Access Compliance Report

Public Rights-of-Way

(Curb Ramps)

Intersection ID: 28416	Main Street: CHASTAIN_PARC_DR	Cross Street: CHASTAIN_WALK_DR	Location:	S
ADA ID: 9BF197C5690B	Ramp Type: Perp	Initial Pass/Fail: Fail	Overall Compliance: No	Severity Score: 1.25

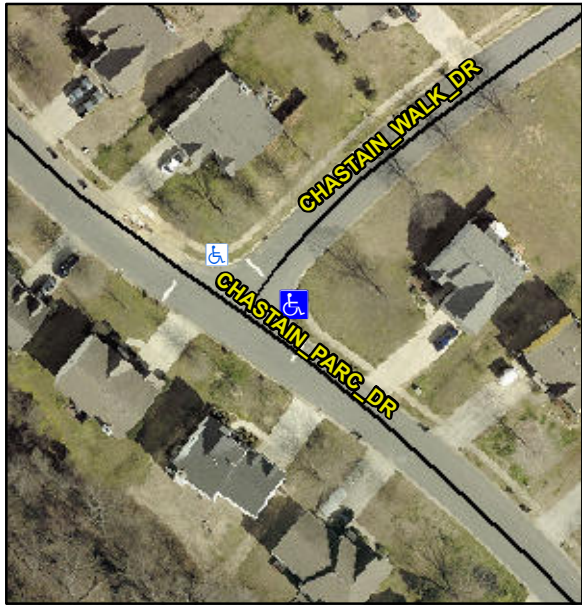
Codes/Mitigation Info/Possible Solution			Field Measurements/Component Compliance					
	Possible Solutions:		Compliance	Description	Data	Compliance	Description	Data
	Remove & Replace Entire Ramp.		N/A	Ramp Length (in)	44.0	Yes	Ramp Slope (%)	7.4
			Yes	Ramp Width (in)	53.5	No	Ramp XSlope (%)	3.2
			N/A	Flare Type LT	N/A	N/A	Flare Type RT	N/A
			N/A	Flare Slope LT (%)	N/A	N/A	Flare Slope RT (%)	N/A
			N/A	Flare Traversable LT?	N/A	N/A	Flare Traversable RT?	N/A
			N/A	Landing Length (in)	N/A	N/A	DWS Provided?	N/A
			N/A	Landing Width (in)	N/A	N/A	DWS Contrast?	N/A
			N/A	Landing Slope (%)	N/A	N/A	DWS Length (in)	N/A
			N/A	Landing X Slope (%)	N/A	N/A	DWS Full Width?	N/A
Surveyor Notes:		N/A	N/A	Landing Curb? (Y/N)	N/A	N/A	DWS Offset (in)	N/A
PROW/ADA:		Not Found, R304.5.3	N/A	Shared Landing?	N/A			
			N/A	Gutter Ponding?	N/A	N/A	Gutter Slope (%)	N/A
			N/A	Gutter Lip Ht (in)	N/A	N/A	Gutter X Slope (%)	N/A
